Re: Florida Power & Light Company
Proposed Turkey Point Units 6 and 7
Docket Nos. 52-040 and 52-041
Voluntary Revised Response to NRC Request for Additional Information Letter
No. 044 (eRAI 6184) – Standard Review Plan Section 02.05.04 –
Stability of Subsurface Materials and Foundations

SRP Section: 02.05.04 – Stability of Subsurface Materials and Foundations

NRC RAI Number: 02.05.04-25 (eRAI 6184)

Figure 1 Geologic Strength Index

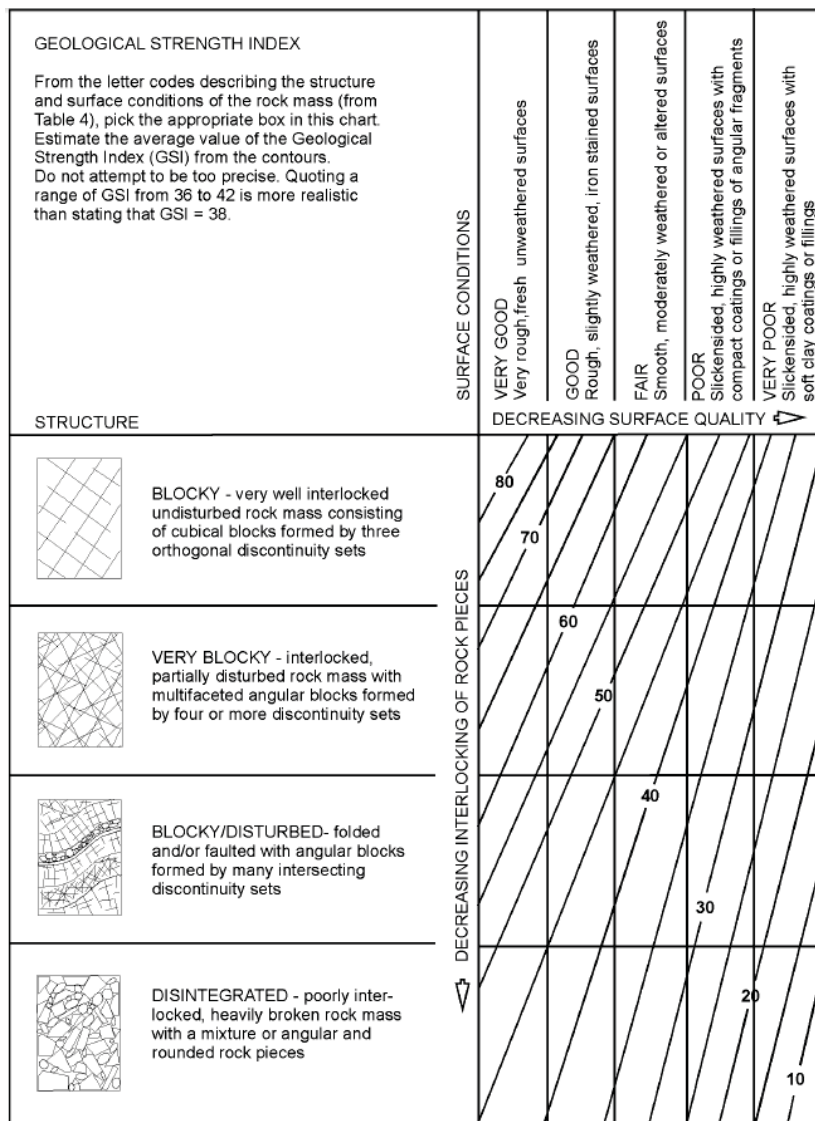
- a) Please discuss how various geologic parameters such as voids and discontinuities (joints, faults, or bedding planes) influenced the overall rock mass behavior and thus, the rock mass classification.
- b) Please describe how the deformation modulus, compressive strength and shear strength parameters for rock mass were accounted for in the foundation stability analysis (settlement, bearing capacity).

Another way of classifying a rock mass is graphically using the GSI system and the discontinuity characterization from the boring logs. GSI specifically accounts for the structure of the rock mass (spacing of discontinuities) on one axis and the joint surface conditions (condition of discontinuities) on the other (Figure 1).

Both GSI and RMR take geologic parameters such as voids and discontinuities into account and can be incorporated into empirical estimates of deformation modulus and shear strength parameters. Deformation modulus and shear strength parameters are used in further calculation of foundation stability.

**Figure 2.5.4-215 Plot of Rock RQD Data with Depth Elevation
(Sheet 1 of 2)**

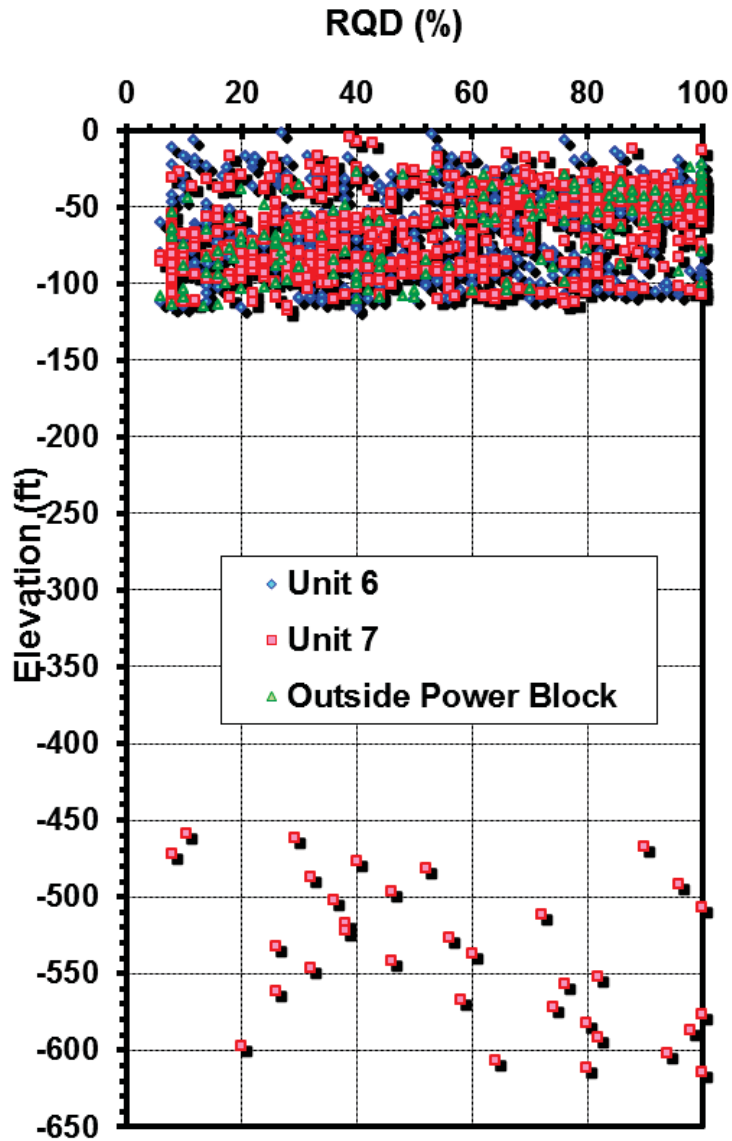
FSAR Figure 2.5.4-215 will be replaced with the following figure in a future revision:

average RQD by layer ranges from 37 percent to 67 percent. Figure 2.5.4-215 (Sheet 1) presents the scatter of RQD values in all rock layers. Figure 2.5.4-215 (Sheet 2) presents the scatter of RQD values in rock layers above El. -150 feet. On Sheet 2, RQD values appear more consistent within layers and a distinction is observed at approximate El. -55 feet between the generally higher RQD values of the Key Largo Limestone and the generally lower RQD values of the Fort Thompson Formation.

Figure 2.5.4-254 Estimated Location of Interpreted FD4 (Slightly to Moderately Fractured) Zones

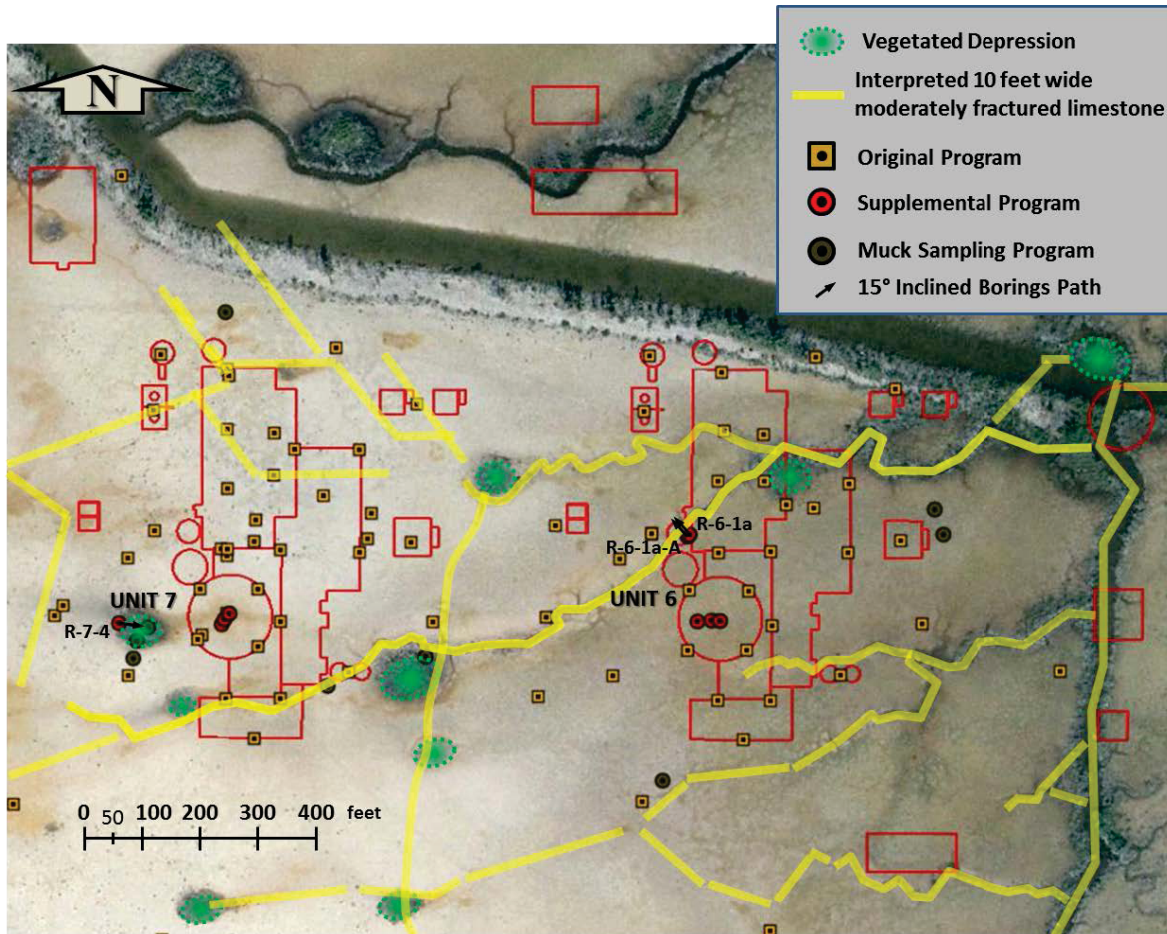
The following figures will be added in a future revision:

Other zones of fracturing between FD1 and FD4 are possible in areas where there is no evident sign of permanent vegetation and drainage; however, only healed vertical fractures (R-6-1b, R-7-1, B-620), one healed near horizontal fracture (R-6-2) and one area with an open horizontal fracture and a 60 degree fracture (R-7-2) are described at the site outside of the vegetated areas. The estimated locations of likely fractured zones are indicated in Figure 2.5.4-254.

Three inclined borings intersect the interpreted FD4 zone, which covers significantly less area, and exists beneath the vegetated depressions and drainages (Figures 2.5.4-254 and 2.5.4-255). Not all core runs under vegetated depressions and drainages are characterized as fracture density FD4, but this is considered as the worst-case fracture density under the investigated depression and drainage footprints.
